Access Compliance Report Public Rights-of-Way (Curb Ramps)

Main Street: CECIL_PASTURE_RD Cross Street: CROWN_VALLEY_PKWY Location: SW

ADA ID: RPRK211026121243 Ramp Type: Type 1 - Perpendicular Diagonal Initial Pass/Fail: Fail Overall Compliance: No Severity Score: 30

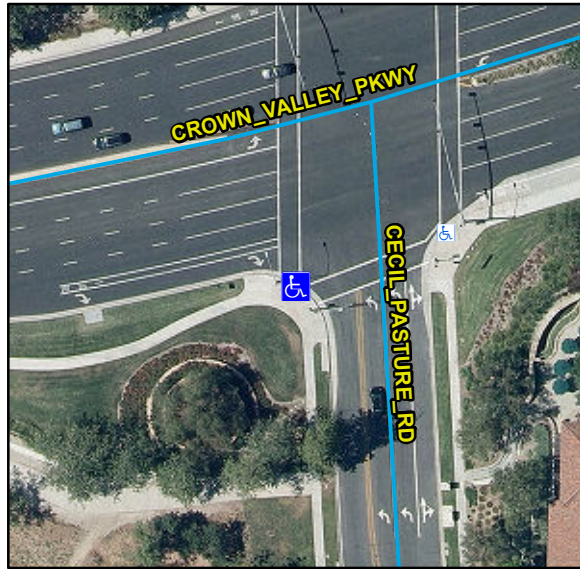
R304.2.2, R204.3, R304.5.3, STD 1115

Remove & Replace Curb Ramp With Two New Directional Ramps or Equivalent.
